REVISION LOG	
REVISION:001	DATE: 10-19-23
1. MOVED THE FRONT KNEEWALL INSIDE 1'-0" REDUCING THE SQUARE FOOTAGE. SQUARE FOOTAGE REVISED.	
REVISION:002	DATE: 9-10-24
1. MADE WALK THROUGH REVISIONS 2. ADD ELECTRICAL PLANS	
REVISION:003	DATE: 03-25-25
1. ADD GOURMET KITCHEN OPTION 2. ADD SIDE LOAD GARAGE OPTION

Add dimensions to front of foundation on S1a to allow for brick at the front porch.- JJ - May -14-2025

Lot 195 - Ballard Road

# The Guilford Georgian - LH

SHEET NO.  
S6  
9 of 10

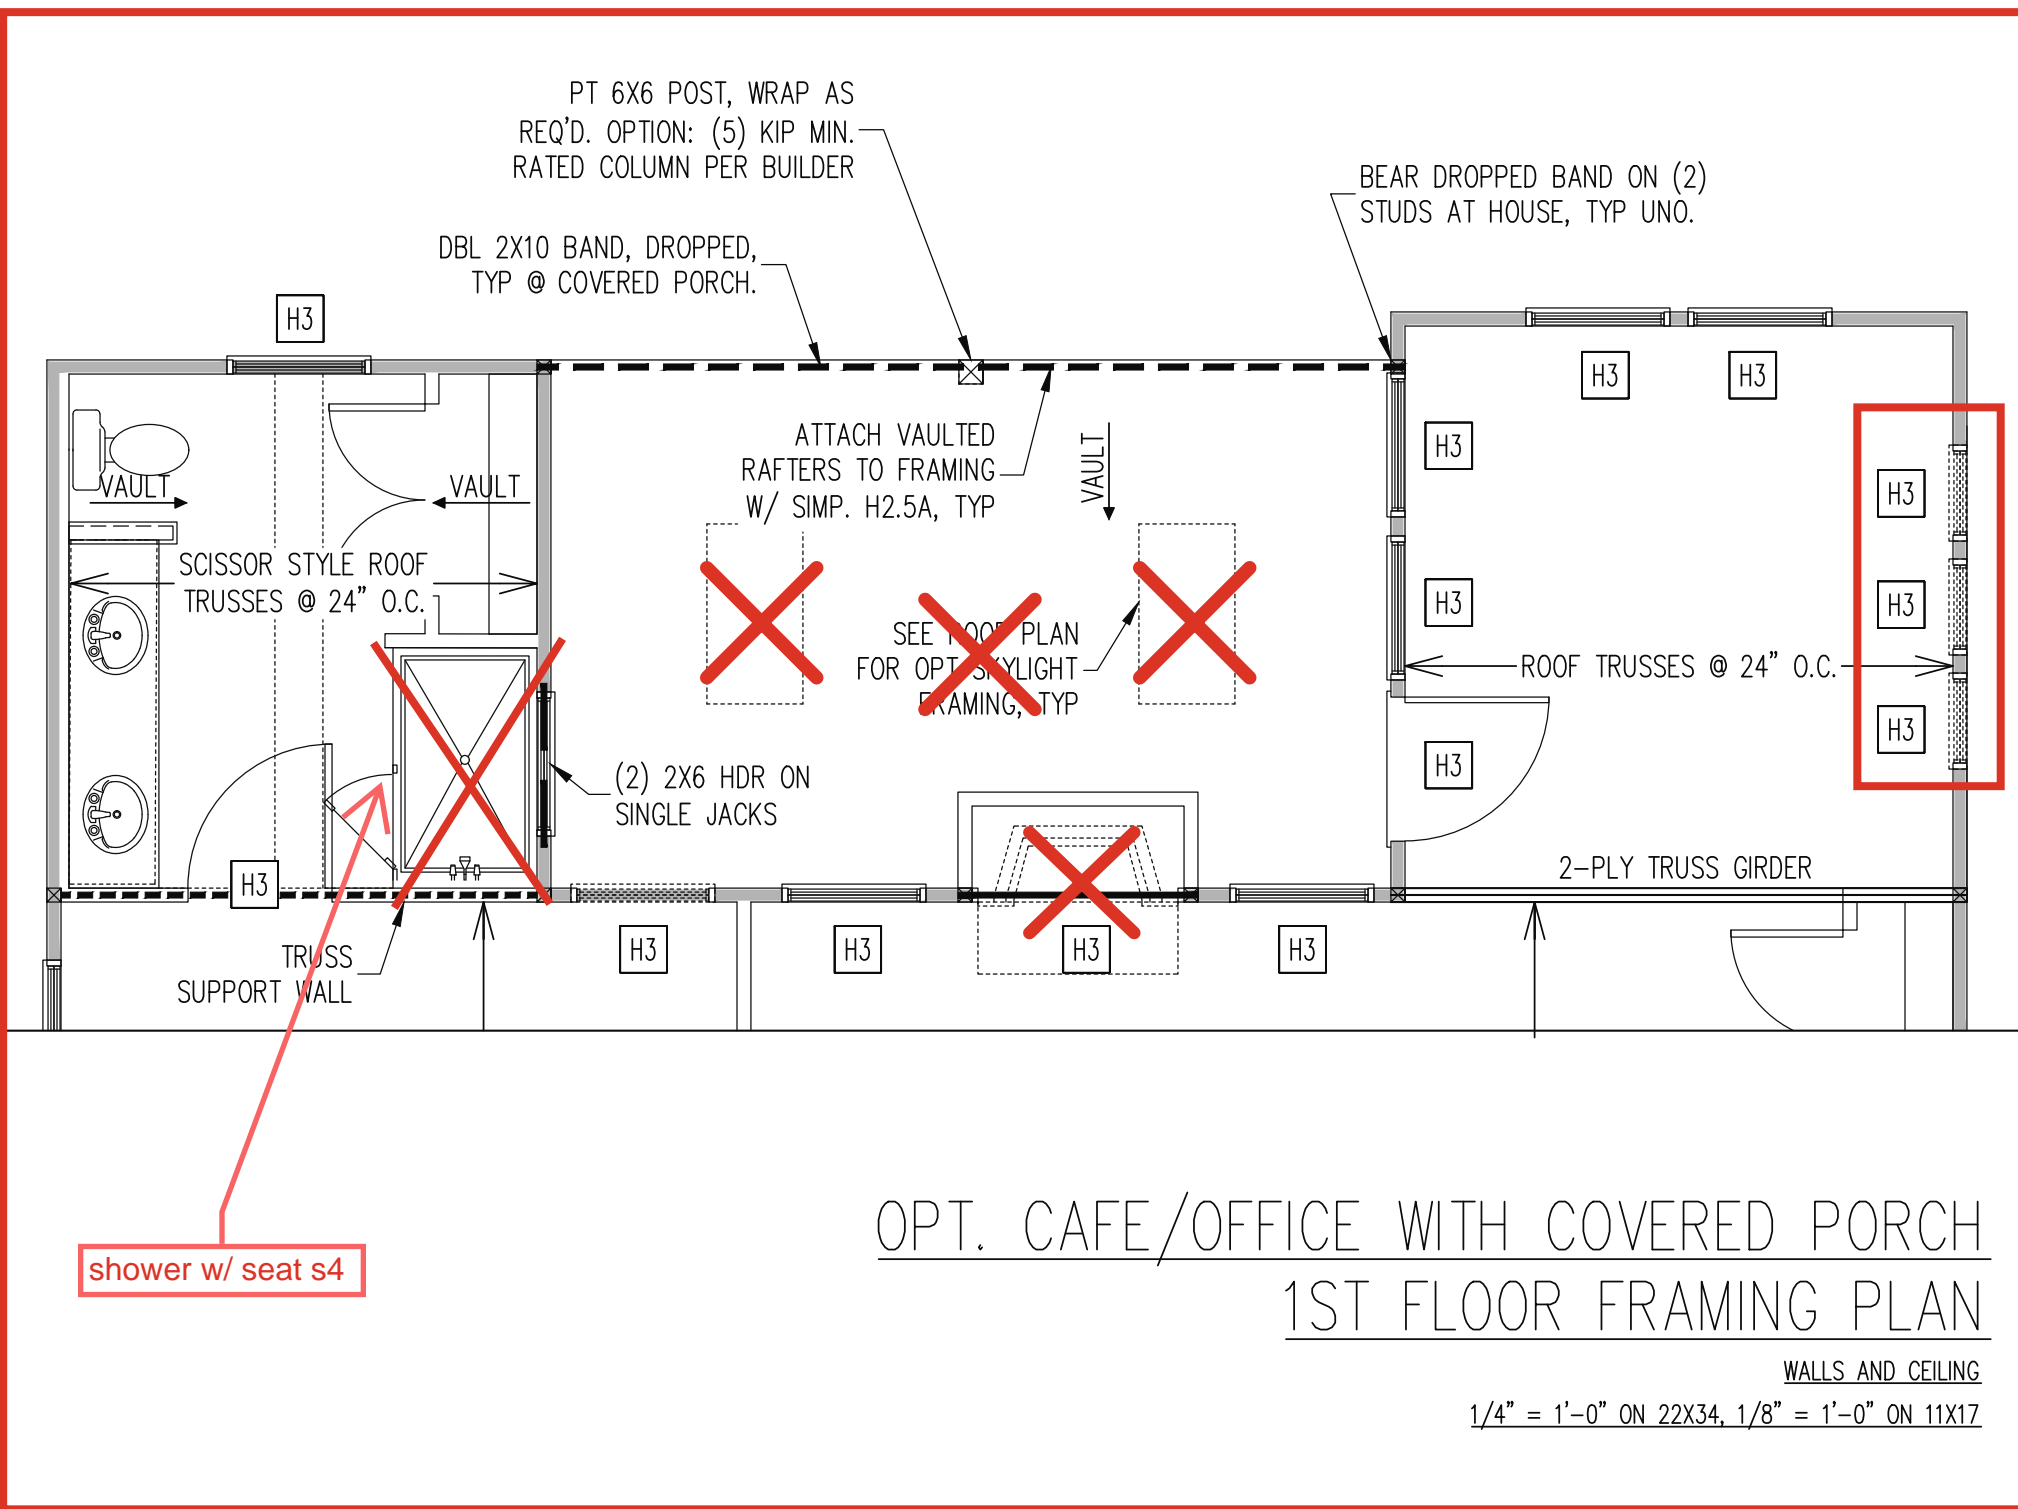
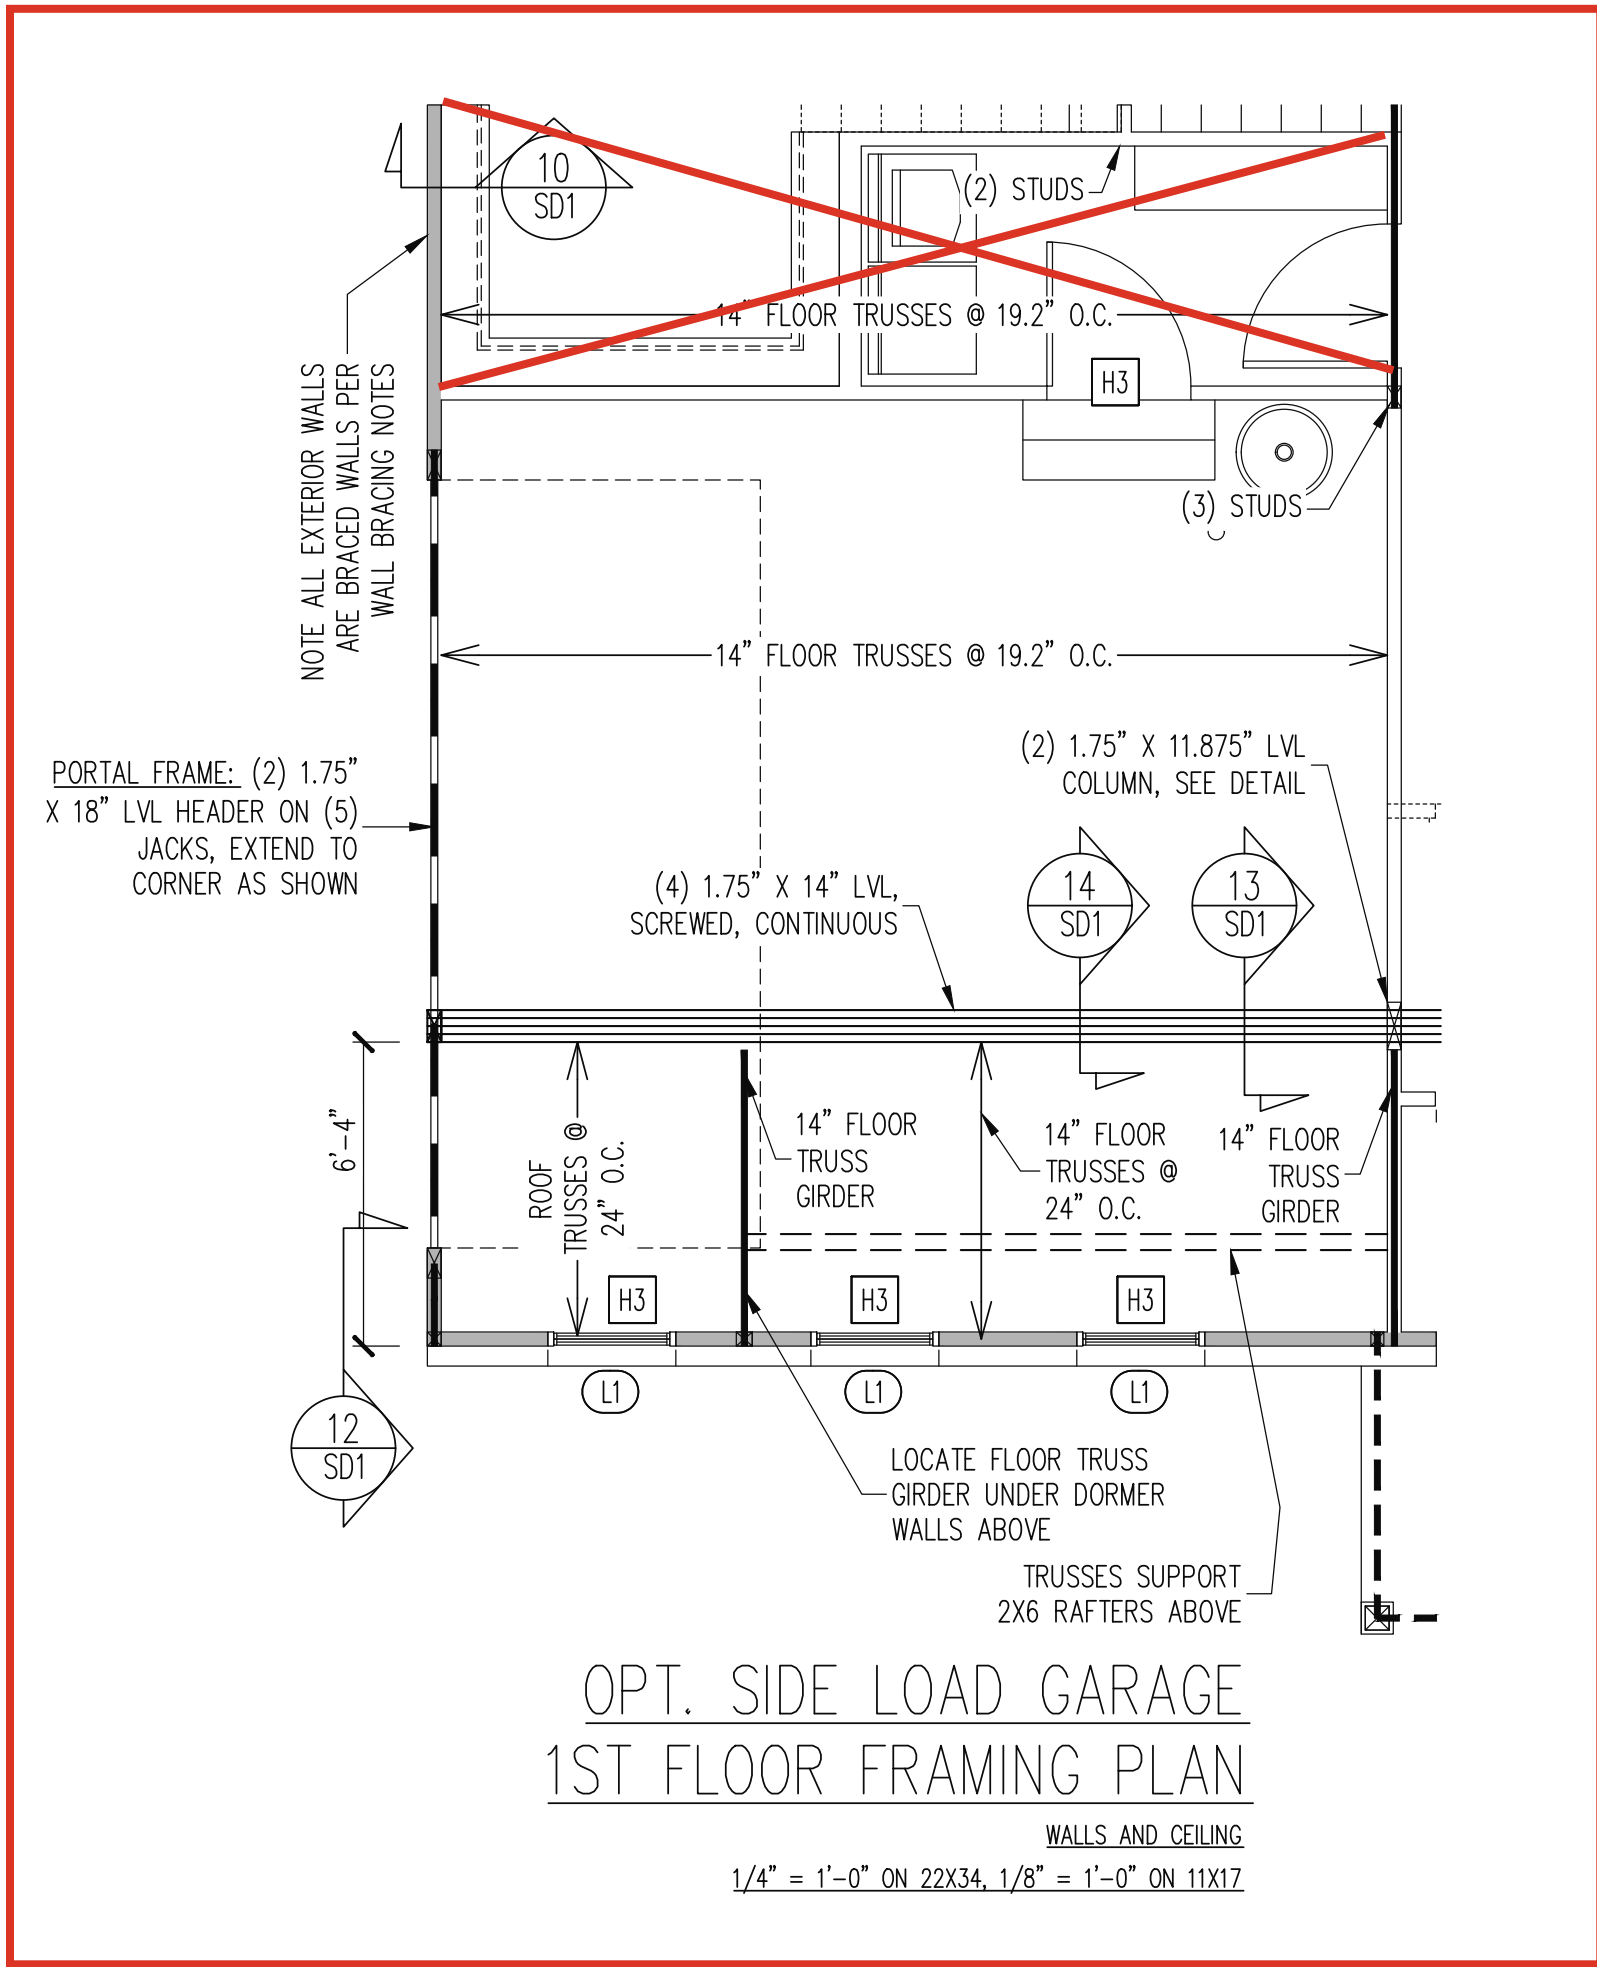
19'-0 1/2" TO  
ALLOW FOR  
BRICK AT  
PORCH

7'-2 1/2" TO  
INCLUDE  
BRICK AT  
PORCH

13'-9" TO  
INCLUDE  
BRICK AT  
PORCH
